July 27, 2010

ADDENDUM NO. 1

**KATY CREEK RANCH, SECTION SIX
BACK LOT RETAINING WALL
WITHIN
HARRIS-FT. BEND COUNTIES M.U.D. NO. 5
FORT BEND COUNTY, TEXAS
VEI Project No. : 12503-006-2-UTL (c&e)**

DRAWING NO.	S-1
DATE	12/11/18
PROJECT	BACK LOT RETAINING WALL
SECTION	SECTION SIX
SCALE	1"=40'-0"
SHEET	1 OF 2

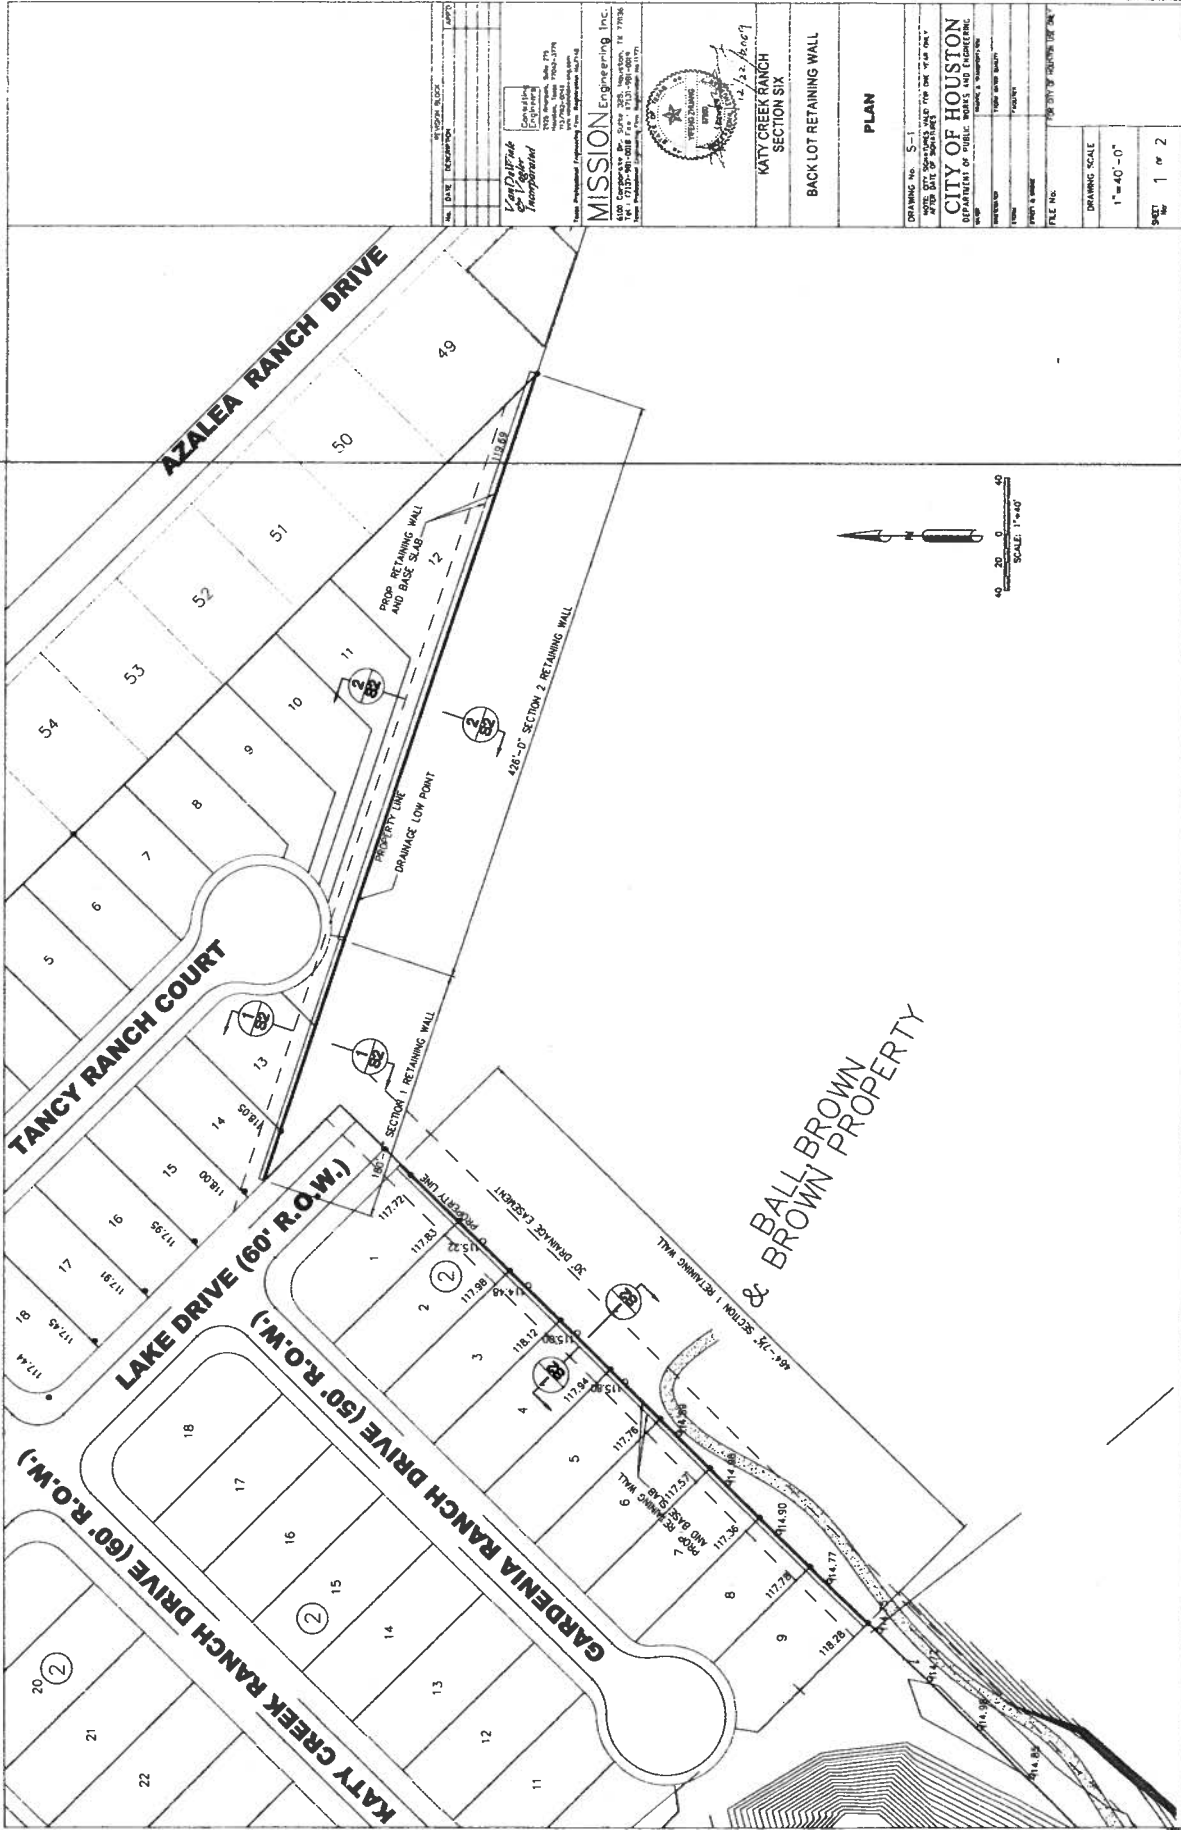
Please note that Sheet 9C-Structural Sections incorrectly indicated the use of a 6-inch perforated pipe along the length of the retaining walls. Attached are the correct Plan View and Structural Sections, which indicate the usage of weep holes. Also, the correct sheets can be viewed on the Van De Wiele & Vogler, Inc. website at www.vandewiele-eng.com/.

No provisions are needed in this bid for the pavement and subgrade indicated on the Wall Section with Traffic Surcharge detail nor for the Fence Posts indicated on both structural details, as the home builder will address these items.

The hardware cloth shall be galvanized welded wire mesh, minimum of 23 gauge, and the openings shall be a minimum of 1/8-inch and a maximum of 1/4-inch.

The water stop detail is needed and is included to ensure that water will drain only through the weep holes and to provide protection against ground loss near the wall joints.
